Access Compliance Report

Public Rights-of-Way

Intersection ID: 53349	Main Street: SAPPHIRE_HILL_LN	Cross Street: N/A	Location: SE
ADA ID: CC50911C7FE1	Ramp Type: Perp	Initial Pass/Fail: Fail	Overall Compliance: No
Severity Score: 1.25			
Codes/Mitigation Info/Possible Solution		Field Measurements/Component Compliance

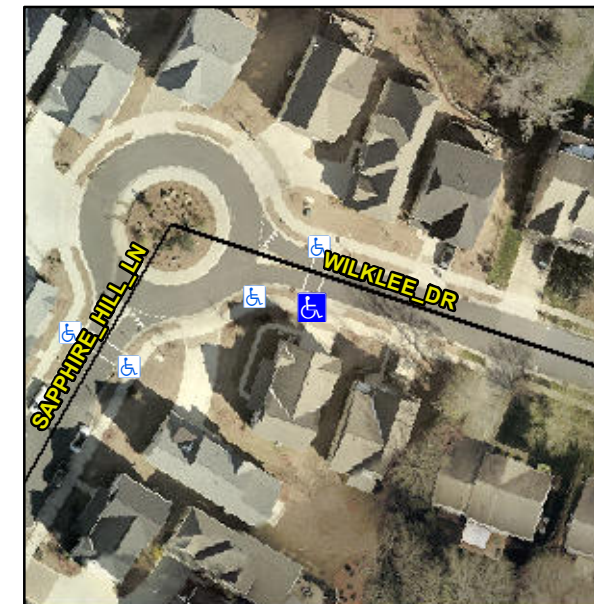
Not Found, R304.5.3

Compliance	Description	Data	Compliance	Description	Data
N/A	Ramp Length (in)	47.0	Yes	Ramp Slope (%)	6.5
Yes	Ramp Width (in)	57.5	No	Ramp XSlope (%)	3.7
N/A	Flare Type LT	N/A	N/A	Flare Type RT	N/A
N/A	Flare Slope LT (%)	N/A	N/A	Flare Slope RT (%)	N/A
N/A	Flare Traversable LT?	N/A	N/A	Flare Traversable RT?	N/A
N/A	Landing Length (in)	N/A	N/A	DWS Provided?	N/A
N/A	Landing Width (in)	N/A	N/A	DWS Contrast?	N/A
N/A	Landing Slope (%)	N/A	N/A	DWS Length (in)	N/A
N/A	Landing X Slope (%)	N/A	N/A	DWS Full Width?	N/A
N/A	Landing Curb? (Y/N)	N/A	N/A	DWS Offset (in)	N/A
N/A	Shared Landing?	N/A			
N/A	Gutter Ponding?	N/A	N/A	Gutter Slope (%)	N/A
N/A	Gutter Lip Ht (in)	N/A	N/A	Gutter X Slope (%)	N/A
N/A	Painted X Walk1?	Yes	N/A	Painted X Walk2?	N/A
	X Walk 1 Direction	To NE		X Walk 2 Direction	N/A
N/A	X Walk 1 Width (in)	88.5	N/A	X Walk 2 Width (in)	N/A
	X Walk 1 Slope (%)	3.7		X Walk 2 Slope (%)	N/A
	X Walk 1 X Slope (%)	3.2		X Walk 2 X Slope (%)	N/A

Remove & Replace Entire Ramp.
